SUBJECT: KEWAUNEE NUCLEAR POWER PLANT - REVIEW OF DRAFT SAFETY
EVALUATION FOR MEASUREMENT UNCERTAINTY RECAPTURE POWER
UPRATE (TAC NO. MB7225)

SAFETY EVALUATION BY THE OFFICE OF NUCLEAR REACTOR REGULATION
RELATING TO AMENDMENT NO. _____ TO FACILITY OPERATING LICENSE NO. DPR-43
NUCLEAR MANAGEMENT COMPANY, LLC
KEWAUNEE NUCLEAR POWER PLANT
DOCKET NO. 50-305

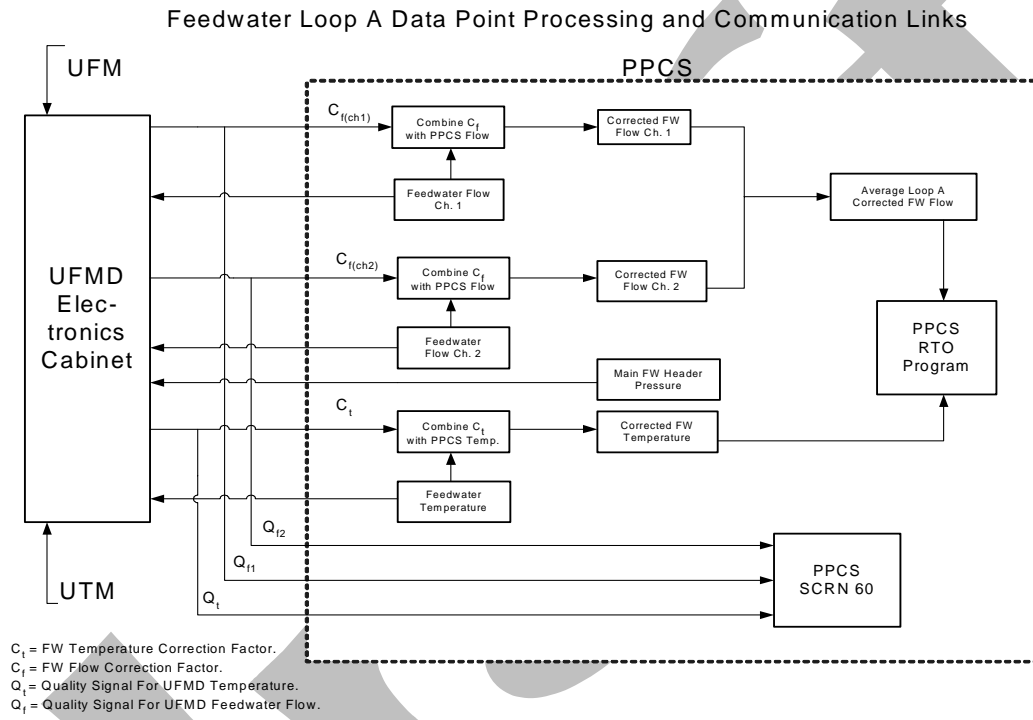
In the licensee's April 30, 2003, letter, NMC provided the figure shown on page 10 for the feedwater alpha or "A" loop data processing and communication links; loop bravo or "B" data processing and communications are identical. This figure was provided as information to

facilitate understanding of the system application at KNPP and depicts the integration and operation of the UFMD system and its interface with the plant process computer system (PPCS). The UFMD electronics cabinet takes inputs from the UTM and UFM sensors in each feedwater loop. These sensor signals are processed using the Crossflow software for the UFM and the CORRTEMP software for the UTMs. The UFMD generated values of flow and temperature are compared with existing venturi flowmeters (venturis) and resistance temperature detector (RTD) signals provided from the PPCS to develop instantaneous and average UFMD correction factors, C_f and C_t , respectively for the two feedwater flow instrument channels (UFM flow/PPCS flow) and feedwater temperature channel (UTM temp/PPCS temp) in each loop. Quality factors, Q_f and Q_t , for each correction factor are generated in the UFMD electronics cabinet by Crossflow and CORRTEMP software and sent to the PPCS screen (PPCS SCRNI). The quality factor data is determined and saved with the corresponding correction factor. The UFMD software running in the UFMD electronics cabinet ensures the correction factors are maintained within the required uncertainty. Individual correction factors for feedwater flow and temperature are provided from the UFMD to the PPCS and are used to calculate the corrected feedwater flow and temperature to be used by the PPCS RTO program. The RTO is used for monitoring reactor power such that the operator can control reactor power to less than the licensed limit and is also used for the daily nuclear power range nuclear instrument calibration.
